CONSTRUCTION AUTHORIZATION PERMIT DENIAL

Re: Application for Repair Permit for property located at 824 Carolyn LN (Parcel ID # 049-252-12),

Health Department file #12207B

SOIL/SITE EVALUATION
for ON-SITE WASTEWATER SYSTEM

PROPOSED PLOT PLAN

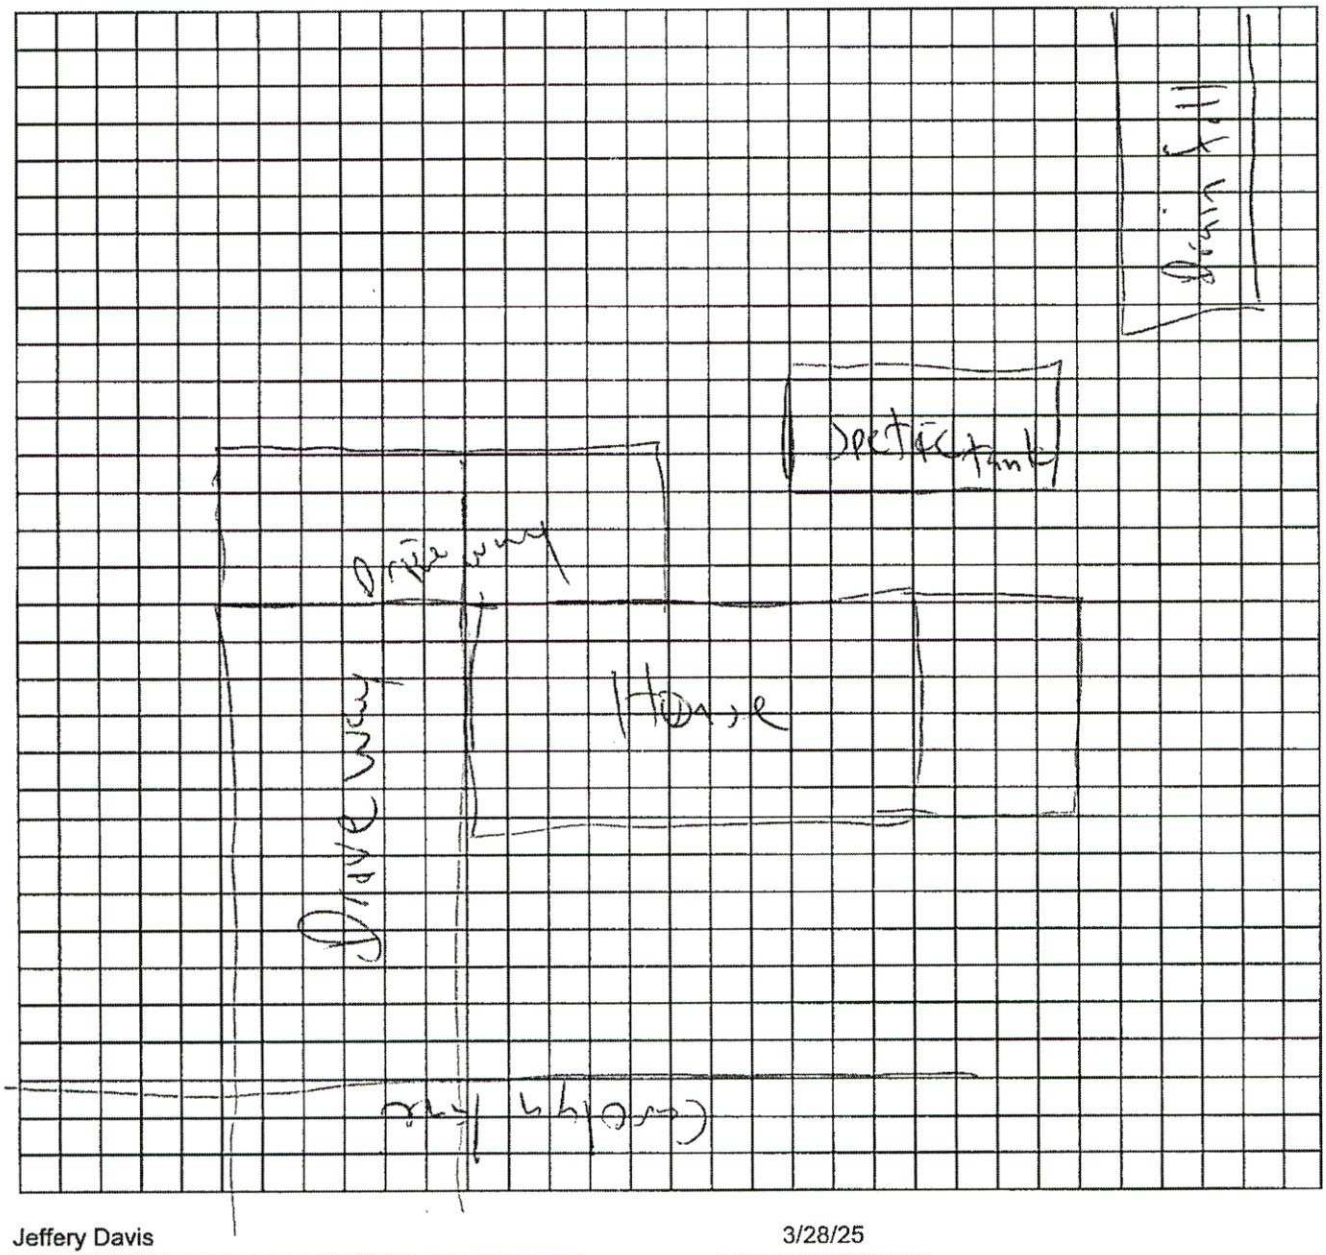
Based on the criteria set out in 15A NCAC 18E .0501 through .0602, the evaluation indicated that the site is **UNSUITABLE** for an on-site wastewater system. Therefore, we must deny your request for an Improvement Permit. A copy of the site evaluation is enclosed. The site is unsuitable based on the following:

☒ Unsuitable soil topography and/or landscape position (Rule .0502)
☒ Unsuitable soil characteristics (structure or clay mineralogy) (Rule .0503)
☒ Unsuitable soil wetness condition (Rule .0504)
☒ Unsuitable soil depth (Rule .0505)
☐ Unsuitable saprolite (Rule .0506)
☐ Presence of restrictive horizon (Rule .0507)
☒ Insufficient space for septic system and repair area (Rule .0508)
☐ Unsuitable for meeting required setbacks (Rule .0601 or .0602)
☐ Other (*Cite applicable rule*):_____
_____
_____

The site evaluation included consideration of possible site modifications, as well as use of all possible systems approved under 15A NCAC 18E. However, the Health Department has determined that none of the above options will overcome the severe conditions on this site. For the reasons set out above, the property is currently classified UNSUITABLE, and no Repair Permit shall be issued for this site in accordance with Rule .0509(a) and (d).

On-site Wastewater Improvement Permit Diagram

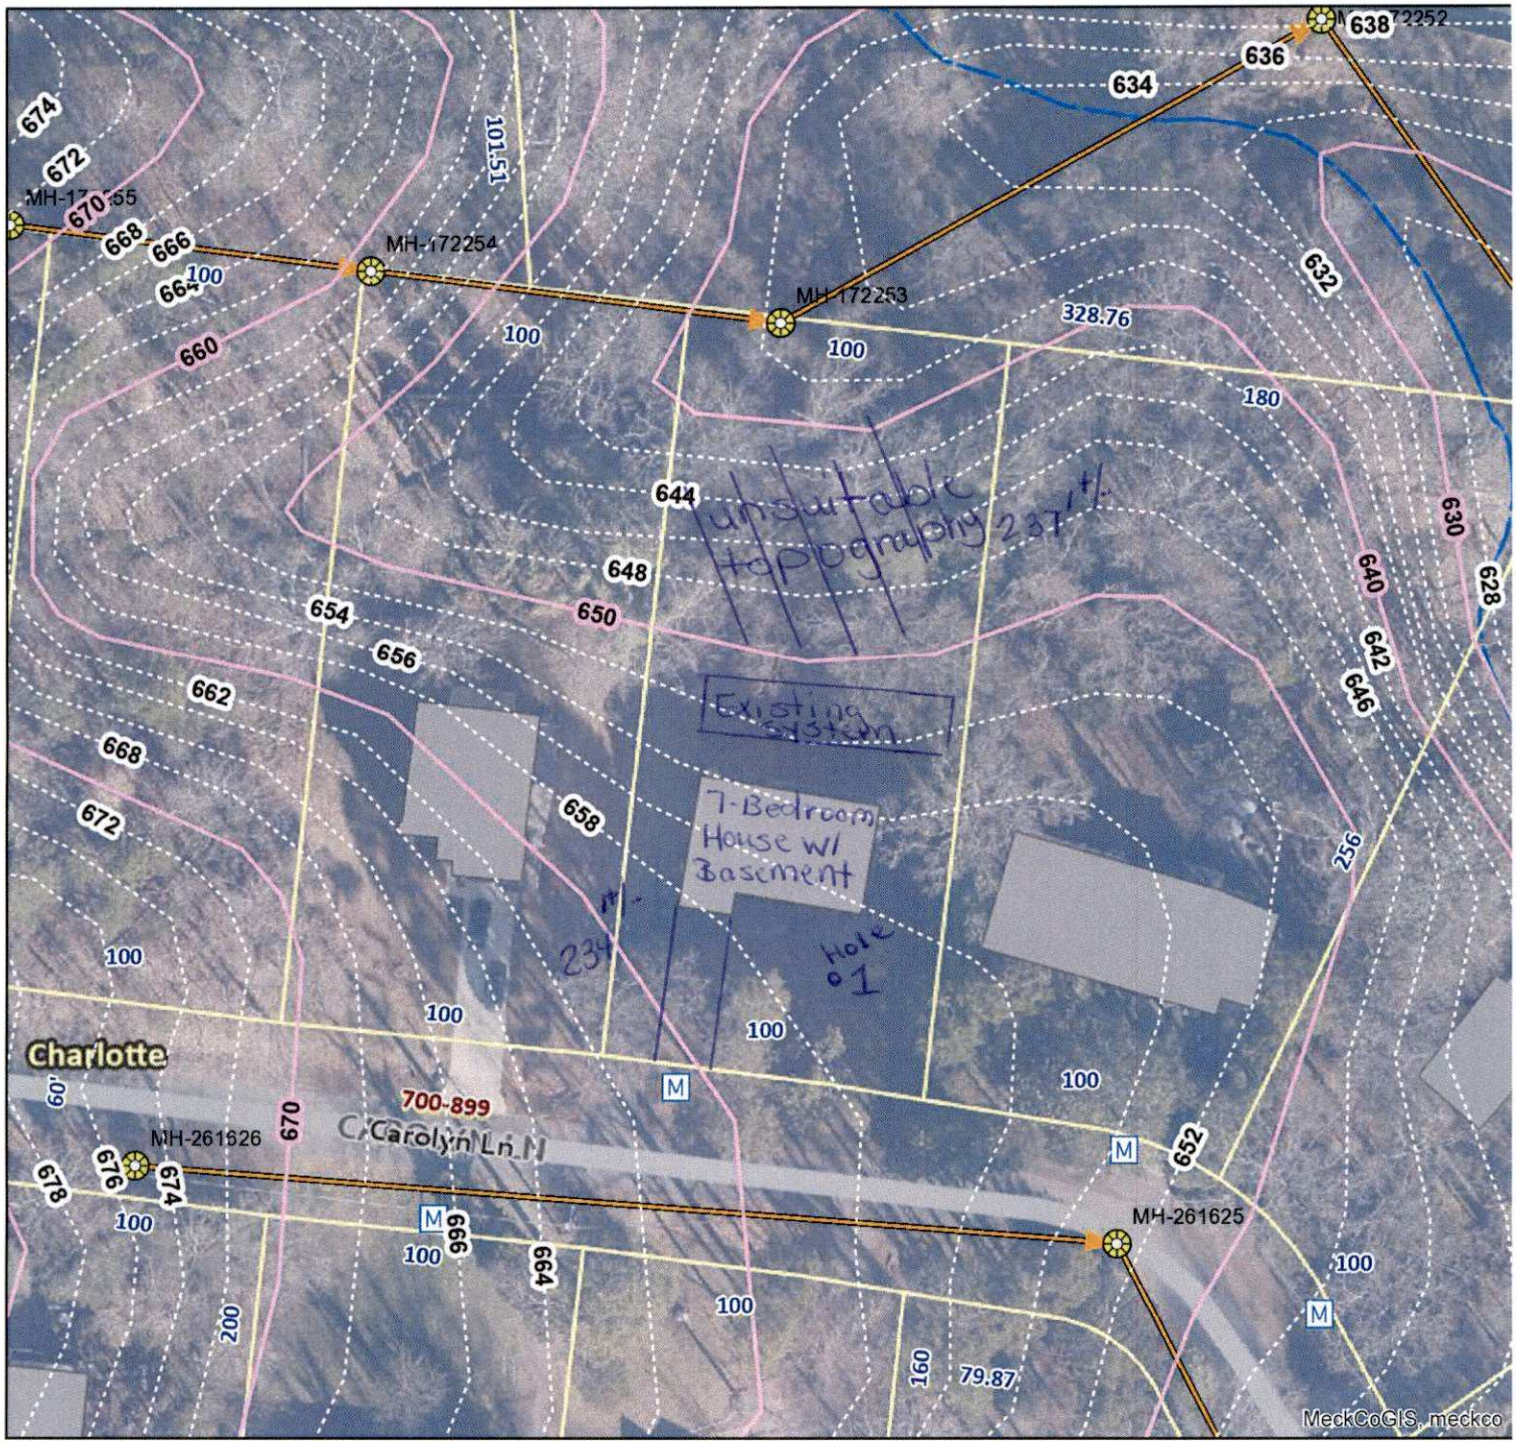
PROFILE #	.0502 Landscape Position/ Slope%	Horizon Depth (IN.)	SOIL MORPHOLOGY .1941 .0503 Structure/ Texture	.0503 Consistence Mineralogy	b PROFILE FACTORS .0504 Soil Wetness/ Color	.0505 Soil Depth (IN.)	.0506 Sapro Class	.0507 Restr Horiz	0.0509 Profile Class & LTAR	0.0502 Slope Correction
1	SS 5%	0-6"	C, WSBK	S,P, FR, SEXP	Chroma 2 6"+	15"	N/A	N/A	US	
		6-16"	C,M	S,P,FR, EXP

Description	Initial System	Repair System
Available Space (.0508)	N/A	US
System Type(s)		
Site LTAR

Soil Evaluation By: April Bumgarner
Site Classificaton (.0509): US
Evaluated by: April Bumgarner
